Re: Supplemental Report for Hillview Drive Slope Repair
Vista Tassajara, Danville, California
SFB Project No.: 768-1

In accordance with the request of the Vista Tassajara Homeowners Association, Stevens, Ferrone & Bailey Engineering Company, Inc. (SFB) has prepared this supplemental report in order to respond to review comments prepared by Cal Engineering & Geology (CEG) in their letter addressed to the Town of Danville, dated June 29, 2017. Previously, SFB prepared a geotechnical engineering report dated June 5, 2017 and also prepared hillside repair plans dated June 2017. Our responses to the CEG comments are listed below in accordance with the numbering system used by CEG in their letter. The information, opinions, conclusions, and recommendations presented below are meant to supplement our previous report dated June 5, 2017; all previous recommendations, conditions, and limitations apply.

APPENDIX C
CONTROL MAP BY MERIDIAN ASSOCIATES

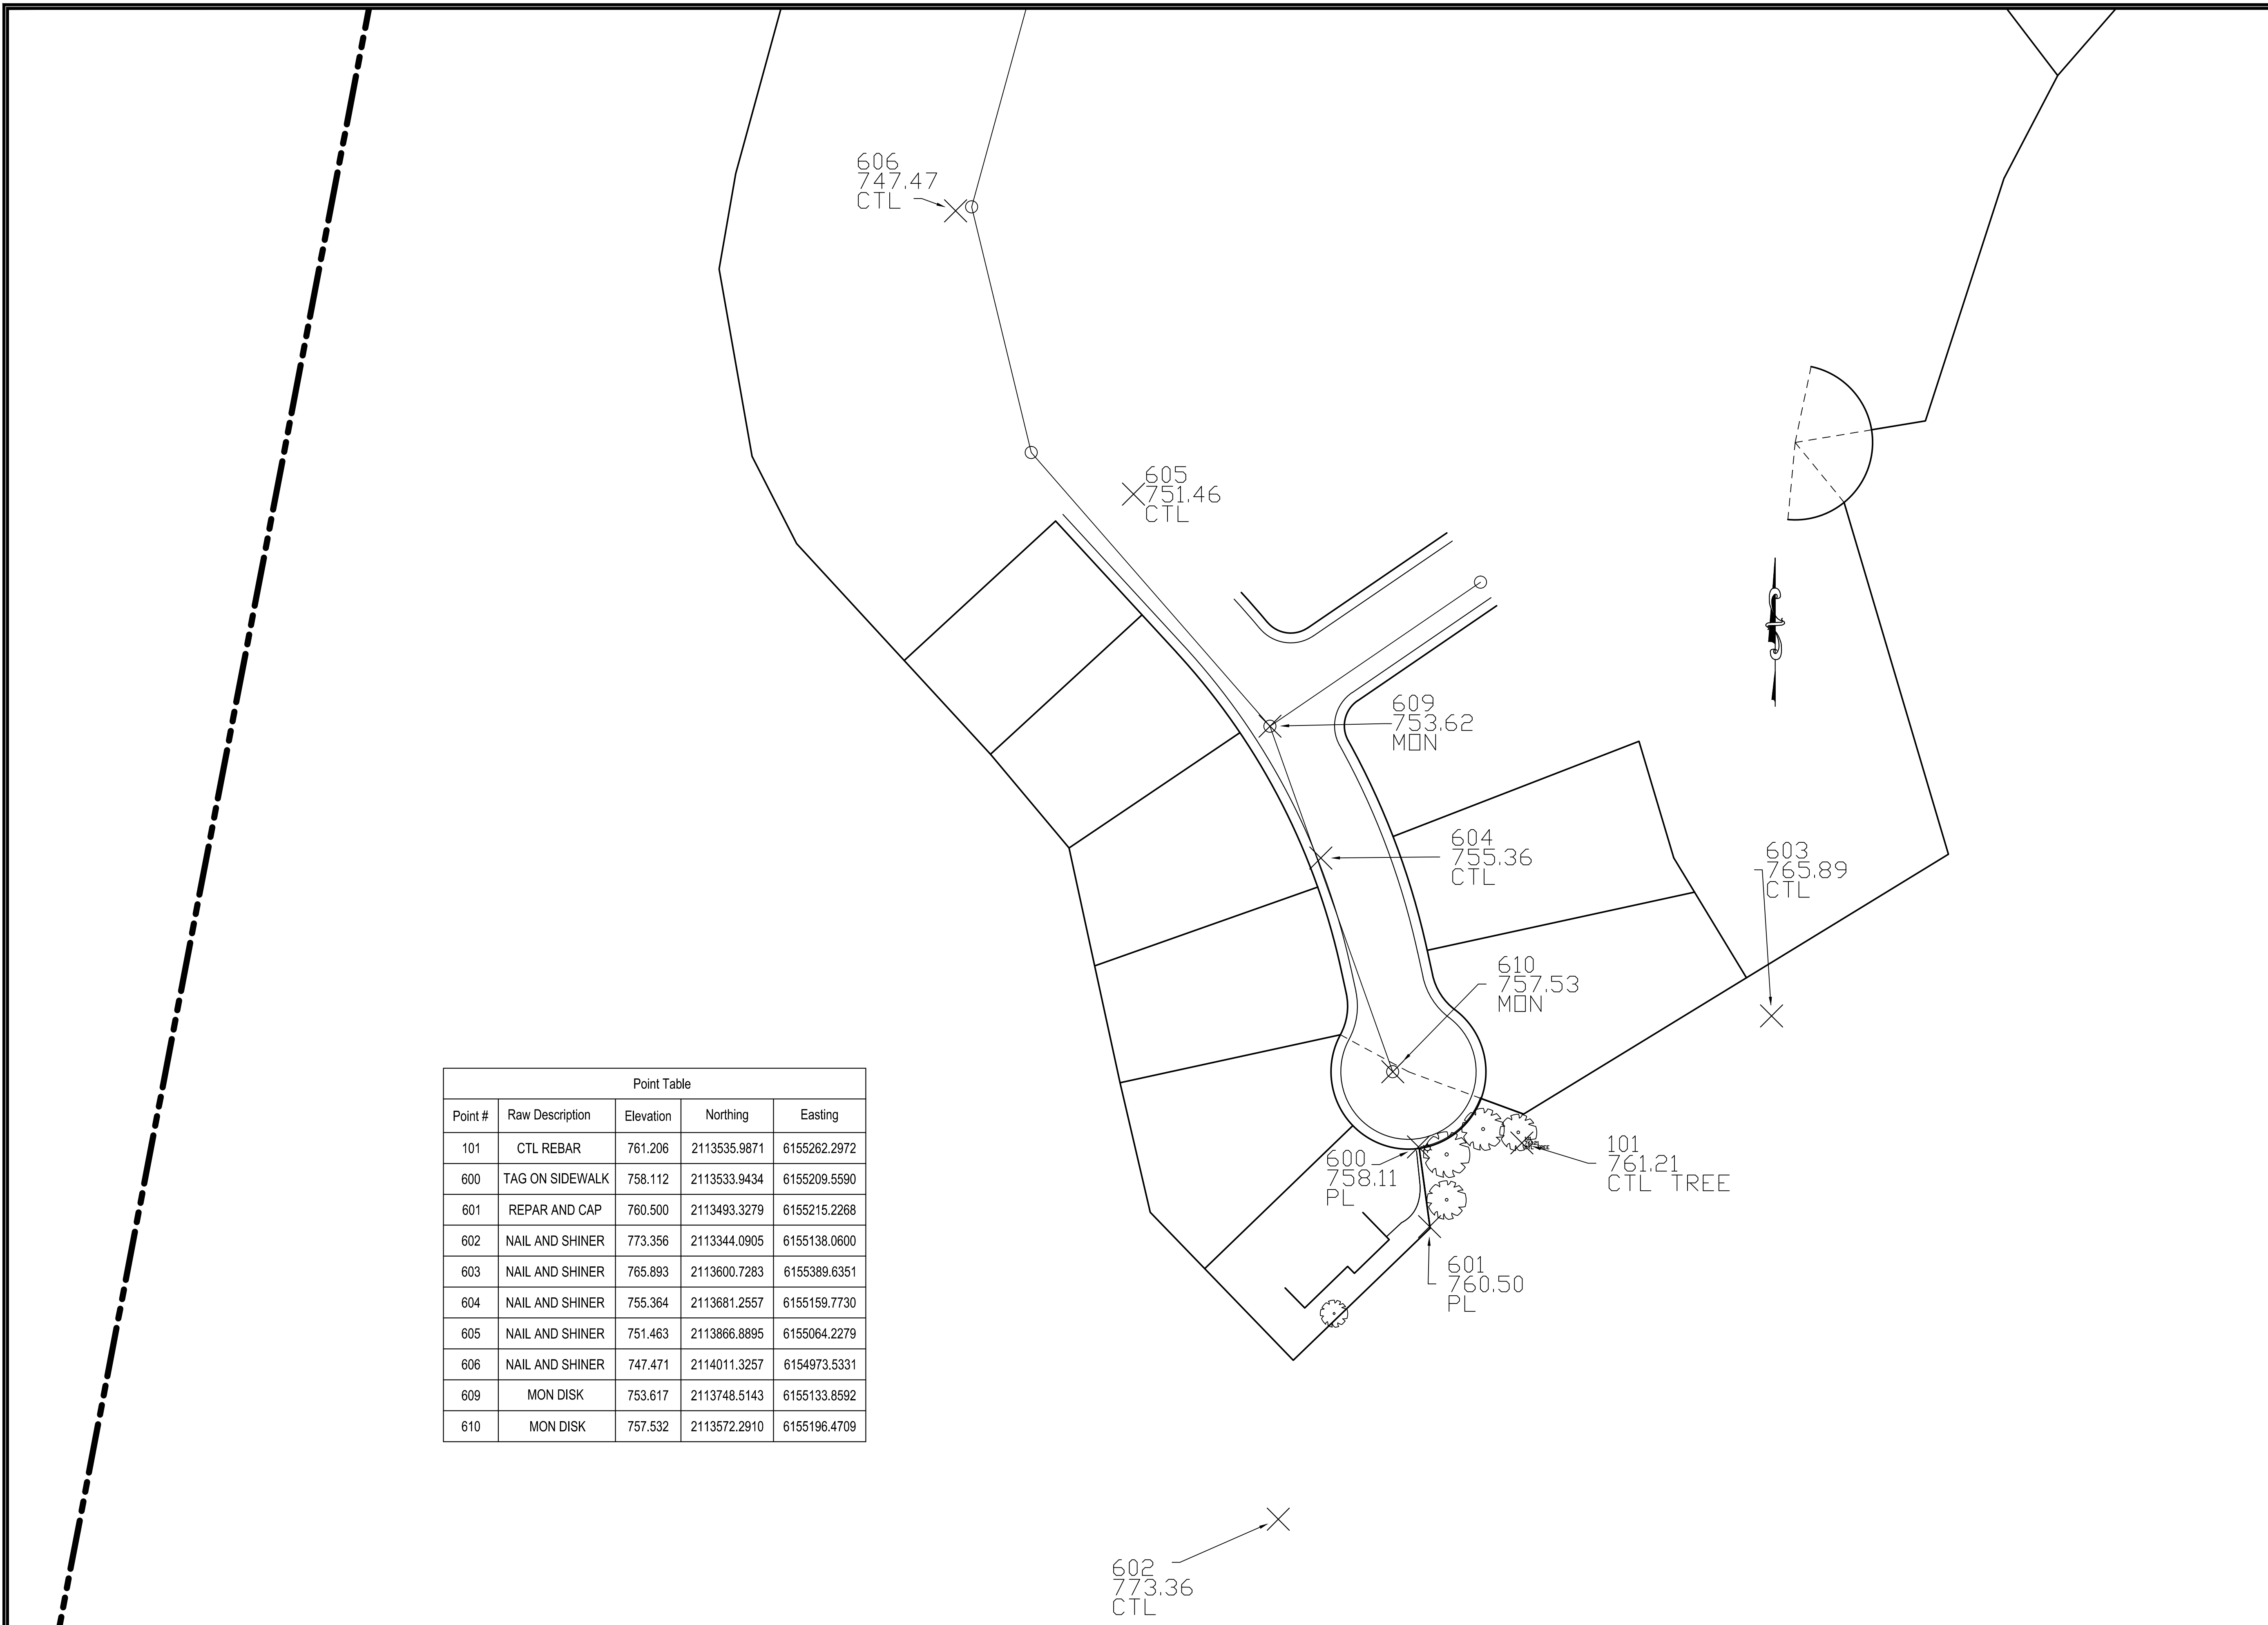
CEG Comment 13 Response: Meridian Associates (the project’s surveyors) have recently prepared a separate plan titled “Control Map”. This plan provides numerous construction control points and their elevation, northing, and easting coordinates. As of July 7, 2017, all construction control points have been set at the site and have been accepted by the grading contractor. As-builts will be prepared based on these control points. A copy of the “Control Map” is attached as **Appendix C**.
